23 March 2026

Reference: SSA_004/Case numbers 208537, 215823, 207995, 215824, 315305, 206750

Letter of Scheme Services Area Allocation for Mirvac Aspect Industrial Estate, 788-882 Mamre Road, Kemps Creek

Figure 1 – sub-catchment plan for Aspect Industrial Estate/basin 7

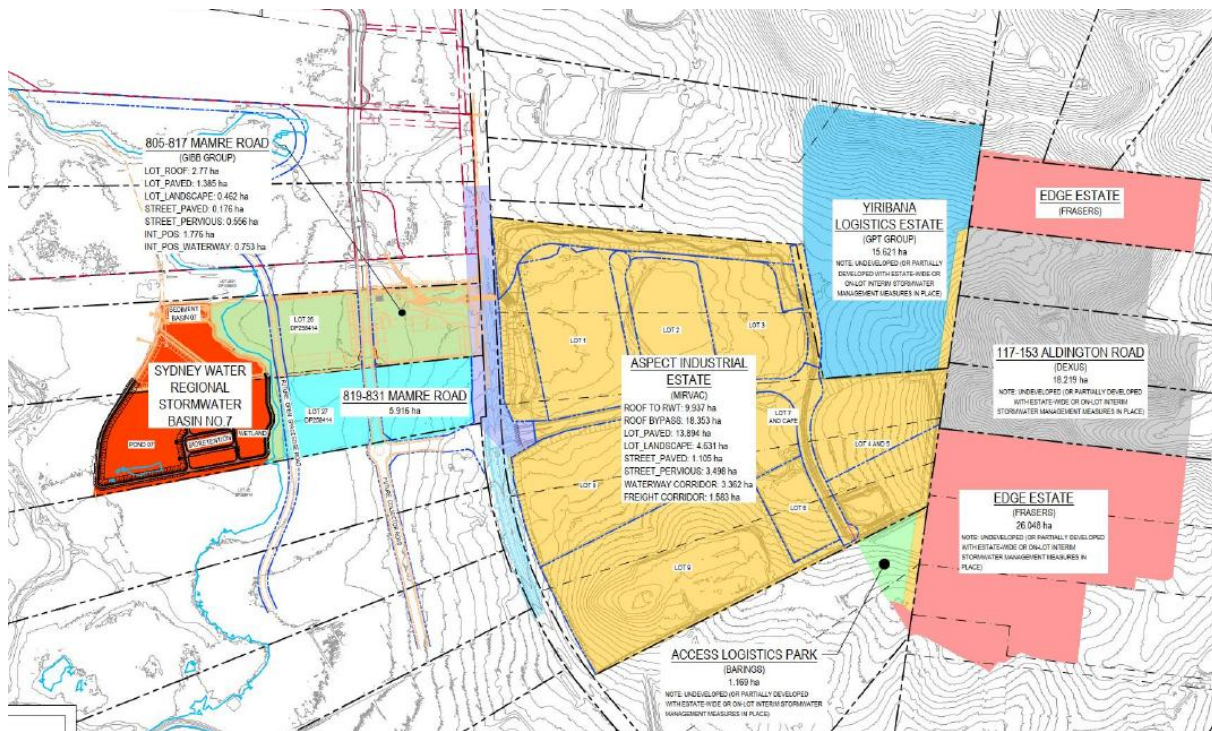
Catchment plan analysis	The catchment plan has been reviewed by internal subject matter experts and is consistent with Sydney Water's assumptions.	See Appendix B
MUSIC model	The model has been reviewed by internal subject matter experts and is compliant with Sydney Water's scheme MUSIC model and with the Wianamatta stormwater Targets.	See Appendix C
Completion of Concept Design	The design has been completed by Gibb Group and reviewed by internal subject matter experts and is consistent with Sydney Water's scheme plan.	See Appendix D
